MEGA HIPPO Mixing Station Frame Modification

To prevent this, modifications to the HIPPO frame and motor have been made. Updated models were released in September, 2020. To assist in obtaining the correct replacement parts for your HIPPO, please see below. All other replacement parts remain the same.

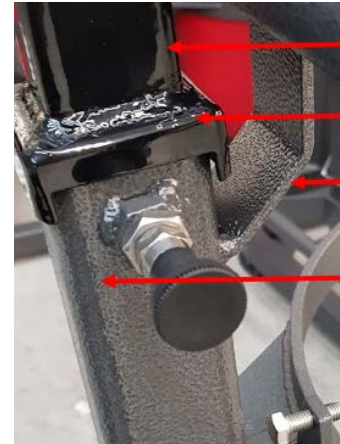
Debris buildup on the motor mount column and the mounting tube was reported, restricting adjustment of the mixing motor and paddle (shown at left).

Larger square profile motor mount (p/n PH606) with splash protection shroud

Updated HIPPO Frame (p/n PH125) with angled bracing strap to prevent interference with splash protection shroud and larger square profile spine.
